**Subject** Status Meeting Notes from May 13, 2019, for the Tyco Stanton Street Facility RCRA Project

# Addendum to 2015 Barrier Wall Groundwater Monitoring Plan Update – Responses to EPA and WDNR comments

# Five-Year Technical Review (FYR) report - Response to Comments(RTC) Agenda

## EPA 14. Figure 2-3

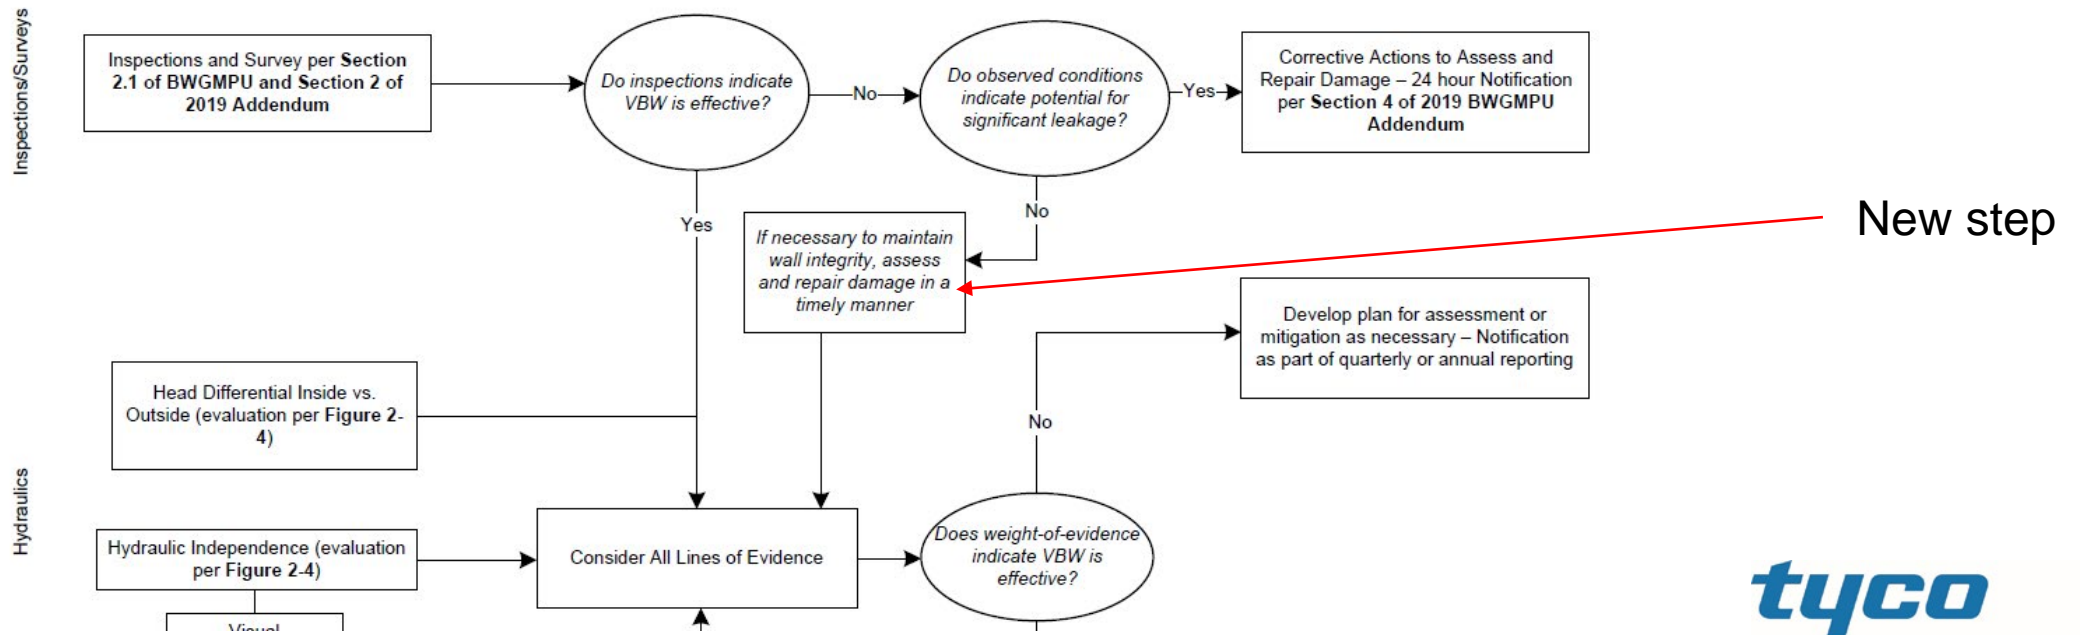
An additional step in this flowchart should be added. If observed conditions do not indicate the potential for significant leakage, the condition that led to the conclusion that the VBW is not effective should be identified and rectified as soon as possible to prevent significant leakage in the future.

This condition has been added to Figure 2-3 to assess and repair damage in a timely manner.

# Response to EPA Comment 8 (Cont'd)

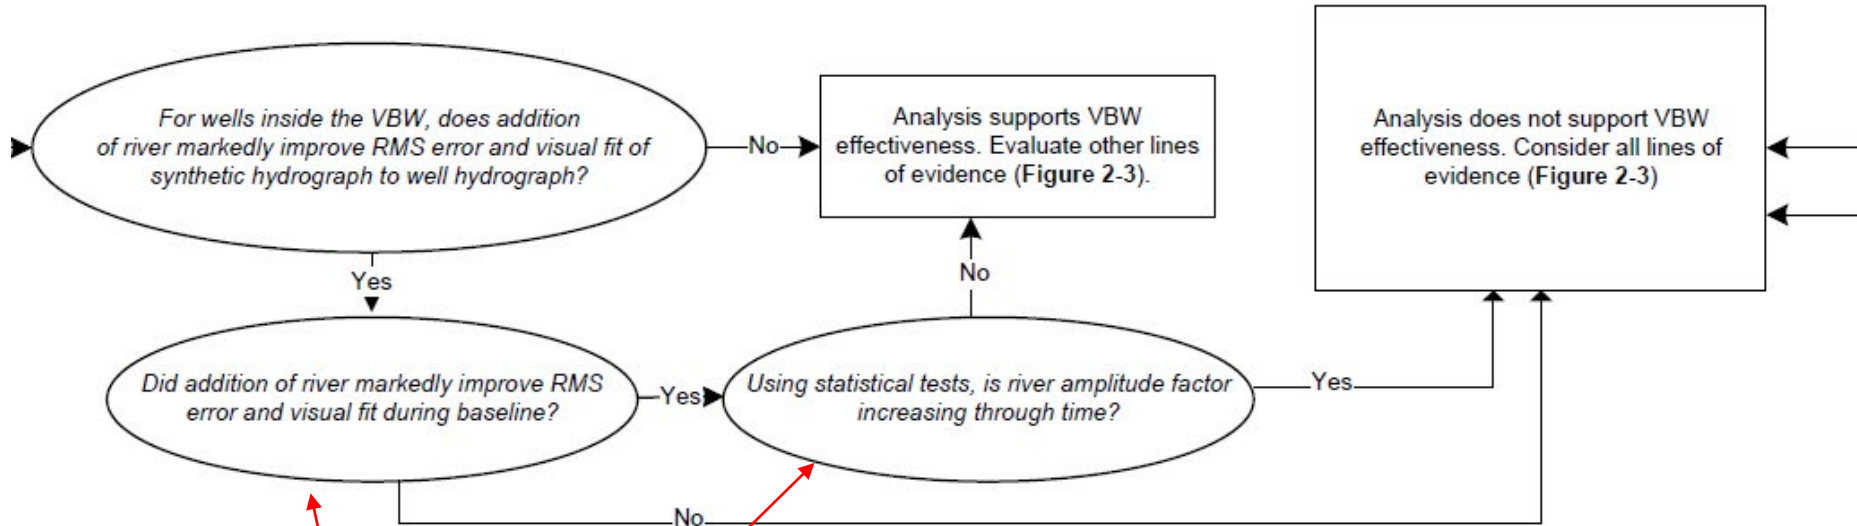
- Discuss root-mean square (RMS) and river amplitude criteria used to assess the degree of hydraulic connection to the river.
- Provide the range of RMS values indicative of acceptable best-fit of water levels and the range or increase from baseline of river amplitude factor that will be used to determine whether further analysis of data is required.

- Ideally RMS errors < 0.03 ft (0.36 inches)
- Higher RMS errors may indicate other influences affecting hydrograph

- If influence from the river found additional time series will be analyzed to see if consistent connection
- If newly detected hydraulic connection to the river (that is, the baseline/previous analyses did not show a connection), then it would be concluded that the hydraulic connection has increased, regardless of amplitude.
- If hydraulic connection indicated previously, then statistical tests for increasing amplitude
  - Mann-Kendall (or similar) analysis (trend through time)
  - Wilcoxon Rank sum (or similar) (are means/medians of two populations same or different)

# EPA Comment 2 on FYR report (cont.)

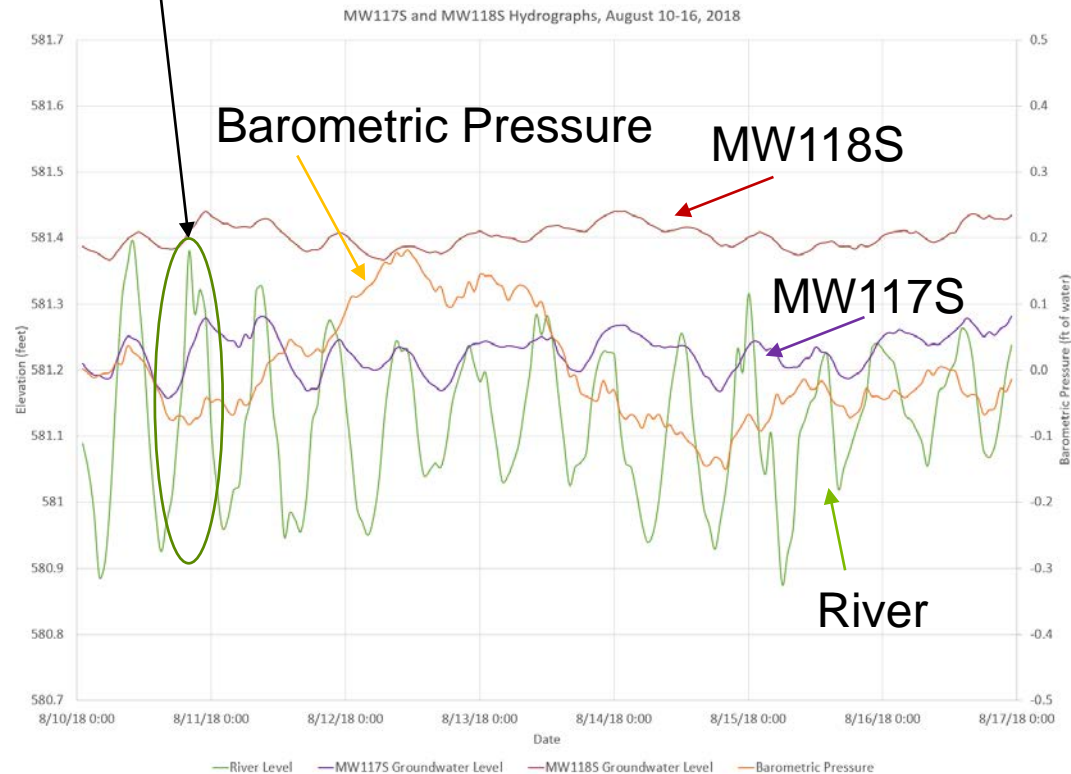
- Outward gradient towards the River often exists
- MW117S and MW118S hydraulic trends indicate that potential leaks in the barrier wall are present in these areas
- Concerns with high concentrations and observed leakage at bolts/seams during O&M inspection

- As presented in August and October 2018, some hydraulic connection may be present even when the barrier wall is acting as designed
- Groundwater flow model simulations indicated that even under a “no breach” scenario, fluctuations in groundwater elevations inside the barrier wall system could occur

MW117S SeriesSEE Synthetics August 10-16, 2018

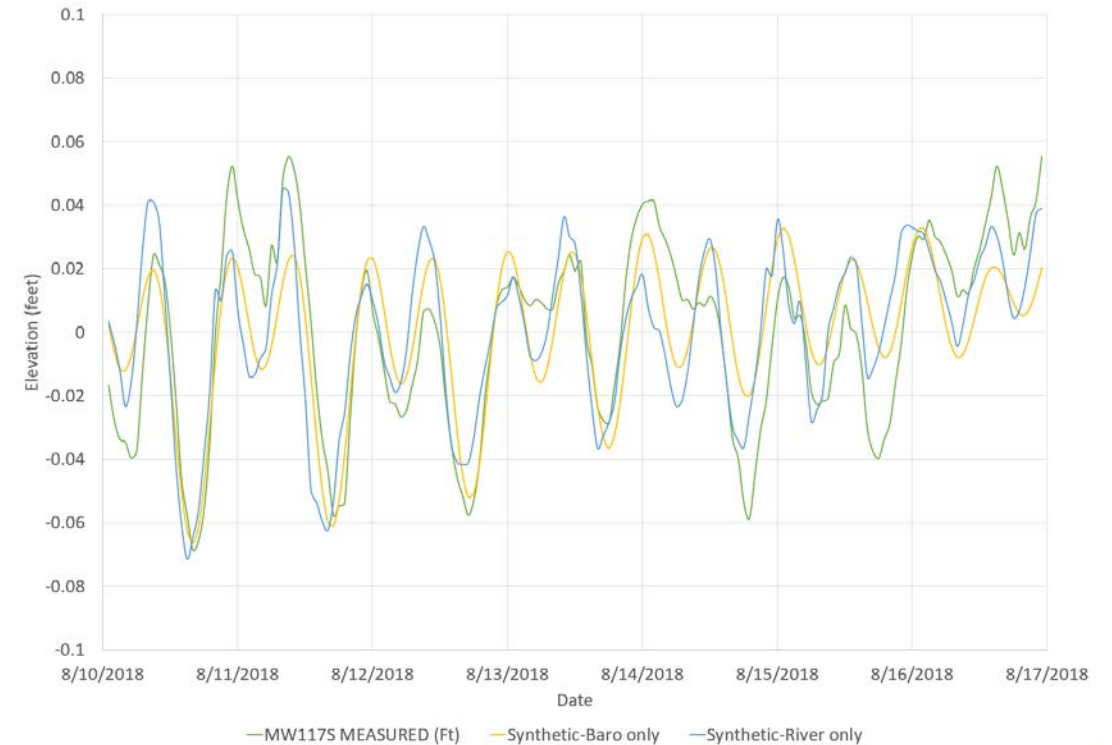
- Visually, it does appear that there is some hydraulic connection, especially at MW117S, however does not account for other factors that SeriesSEE can evaluate
- MW117S max water level change of 0.12 feet near time of 0.46 feet river rise; other responses lower
- MW118S max water level change of 0.06 feet in near time of 0.46 feet river rise; other responses lower

- SeriesSEE analysis conducted
  - Fit did not improve from barometric pressure-only analysis when river considered (similar to 2016-2018)
  - River amplitude factors of 0.14 (MW117S) and 0.08 (MW118S); similar to previous amplitude factors
- SeriesSEE does not indicate hydraulic connection
- Area will be inspected (above and below wall) and SeriesSEE analysis conducted in 2019
- Note that concentrations at MW117 and MW118 well nests are 3 order magnitude lower than the max concentrations noted by EPA
